LINE	QUANTITY	UOP	CAT NO	ITEM NUMBER	UNIT PRICE	AMOUNT
ADDENDUM NO. 04						
ADDENDUM ISSUED TO PUBLISH AND DISTRIBUTE THE FOLLOWING INFORMATION TO THE VENDOR COMMUNITY AS ATTACHED.						
0001	1	LS		968-20		
NEW STATE OFFICE BUILDING IN CLARKSBURG, WV						
***** THIS IS THE END OF RFQ GSD136433 ***** TOTAL:

Addendum Number: No. 04

Addendum issued for the following informational changes and updates.

Clarksburg State Office Building
GSD 136433

A612

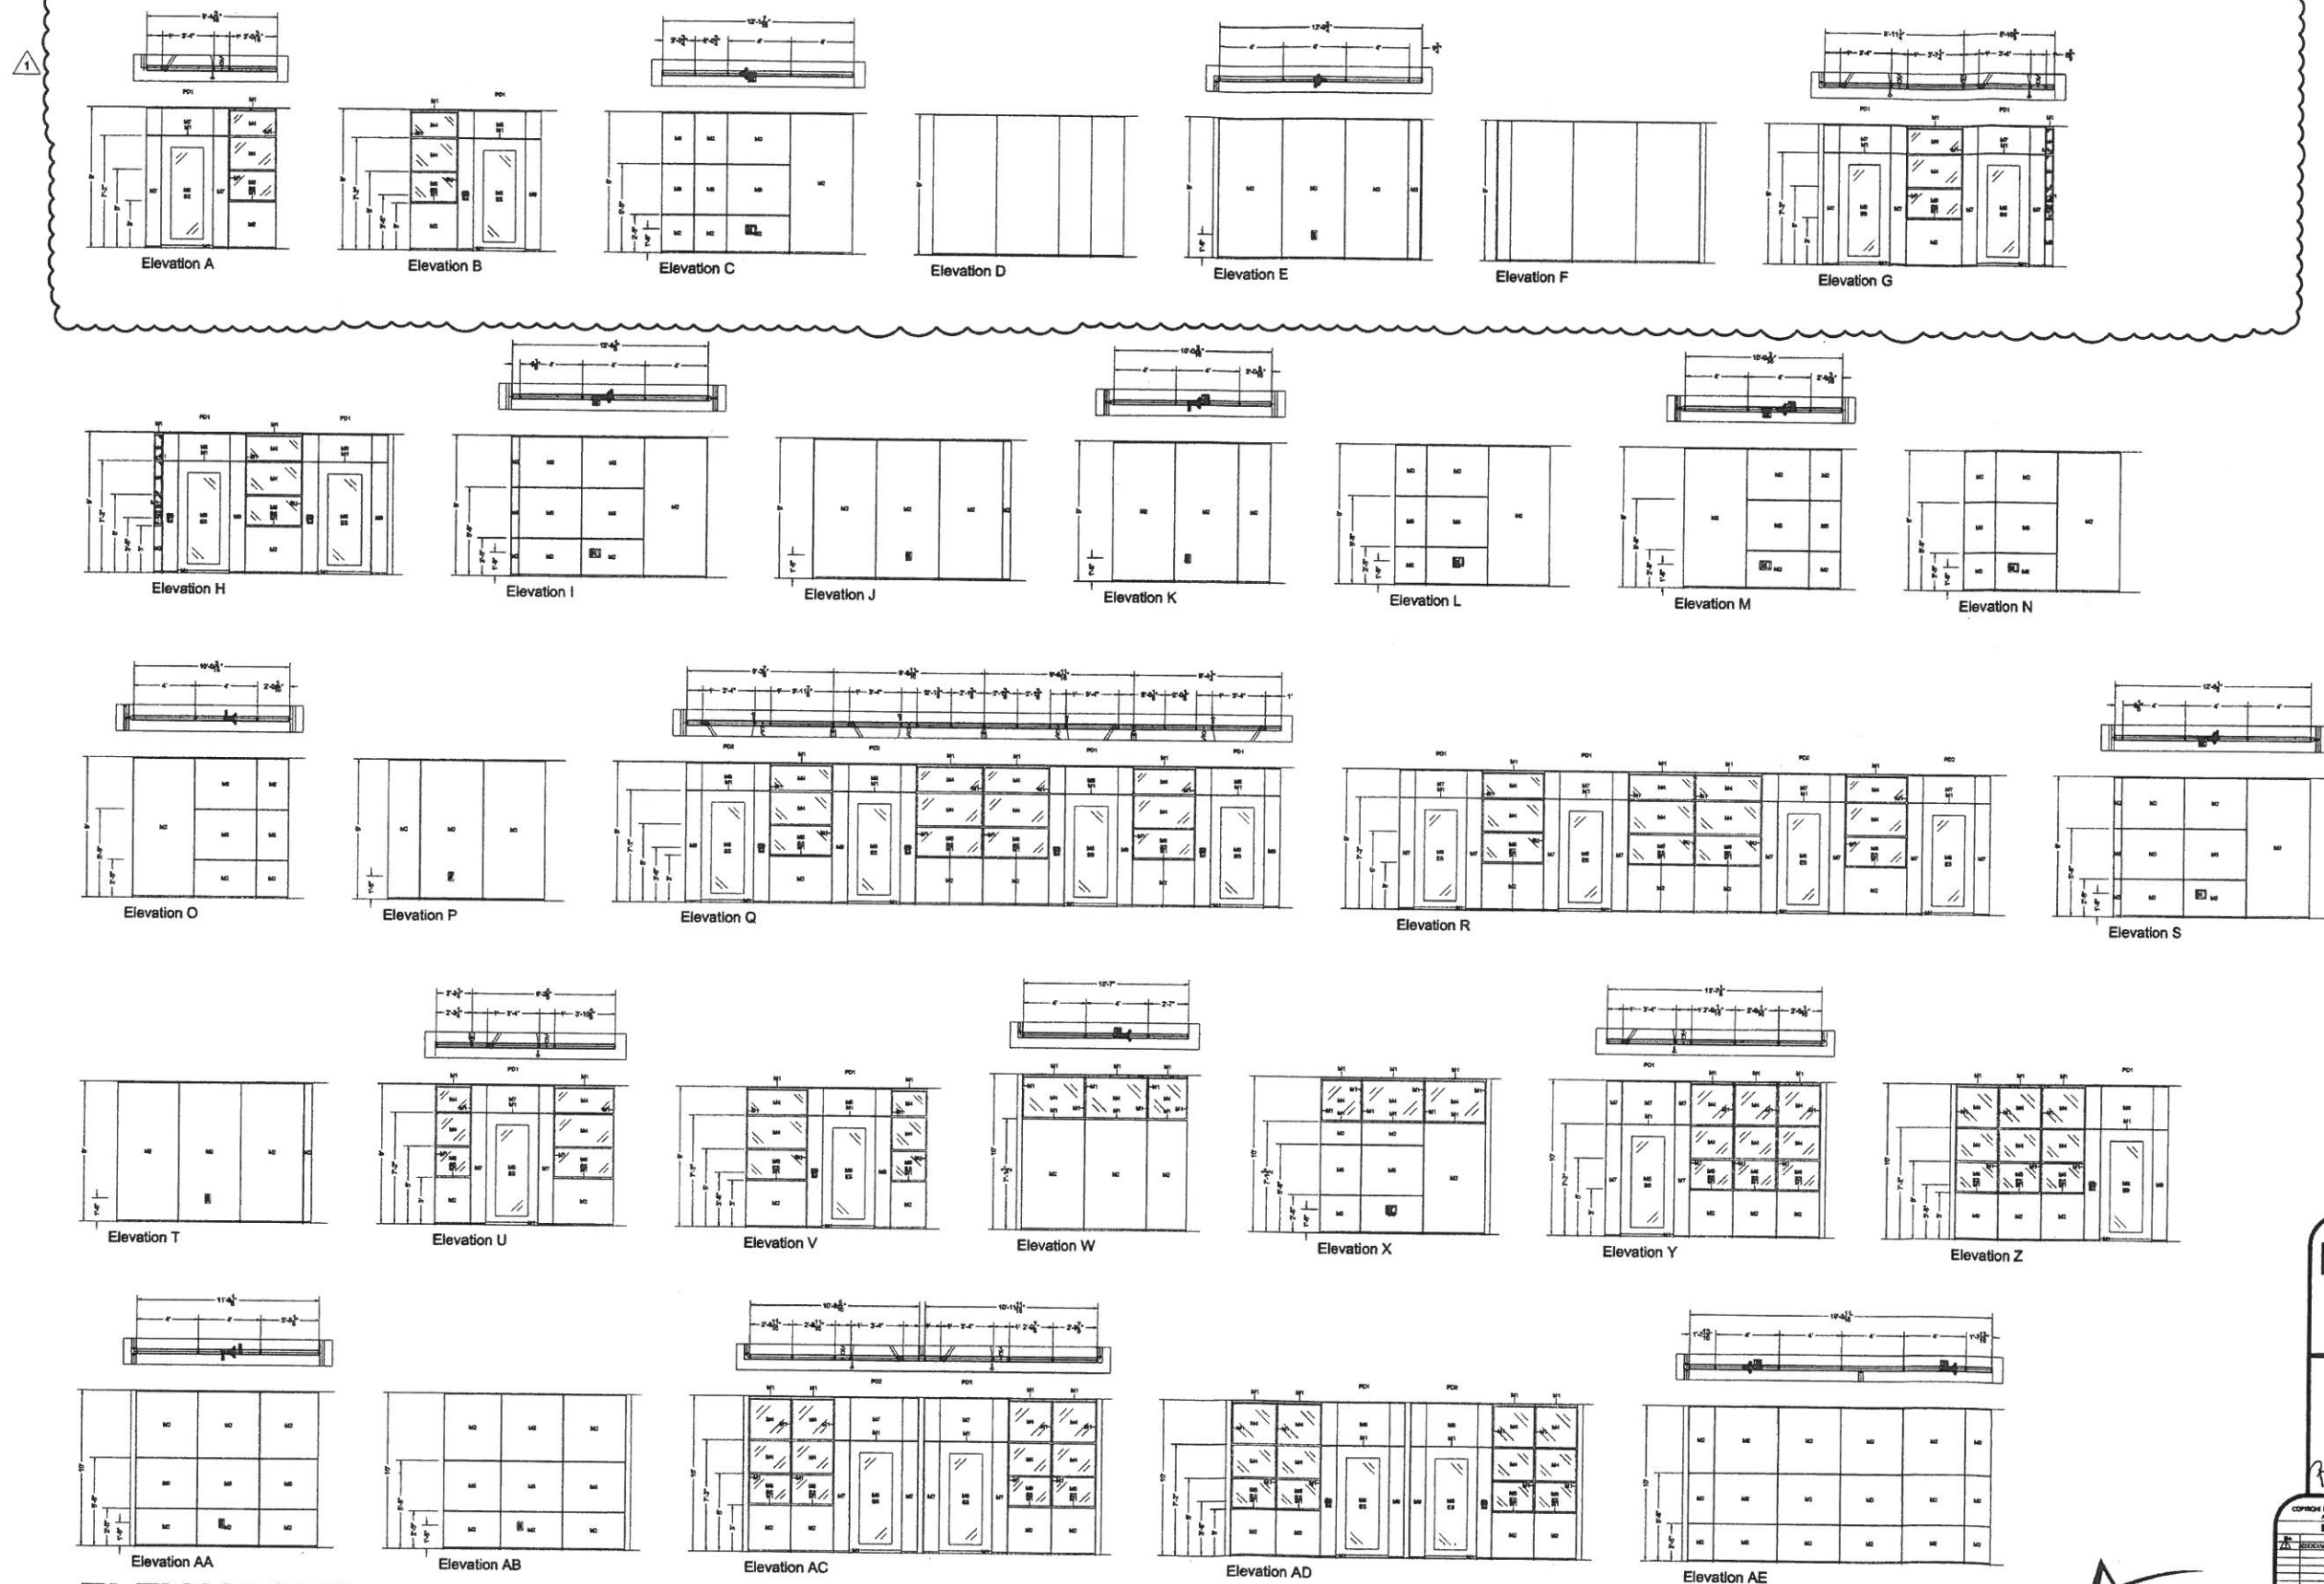
- 3.12** Sheet A611, A612, A615
OMIT: A611, A612, A615 as found in the Issued for Bid set.
ADD: A611, A612, A615 as appended to this document.
